Access Compliance Report

Public Rights-of-Way

(Curb Ramps)

Intersection ID: 26538	Main Street: FONTAINE_CT	Cross Street: TARLETON_TWINS_TR	Location: NE
ADA ID: 1C5FC0D92948	Ramp Type: BlendTrans1	Initial Pass/Fail: Fail	Overall Compliance: No
			Severity Score: 36.25

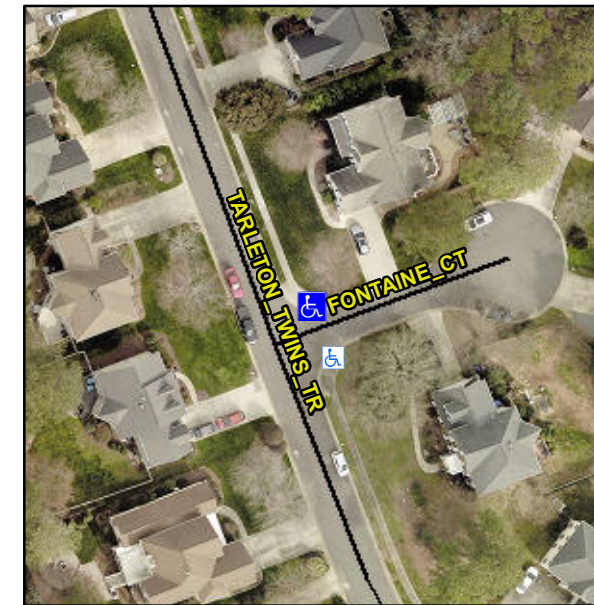
Not Found, R304.5.1, R304.5.3

Remove & Replace Curb Ramp With Two New Directional Ramps or Equivalent.
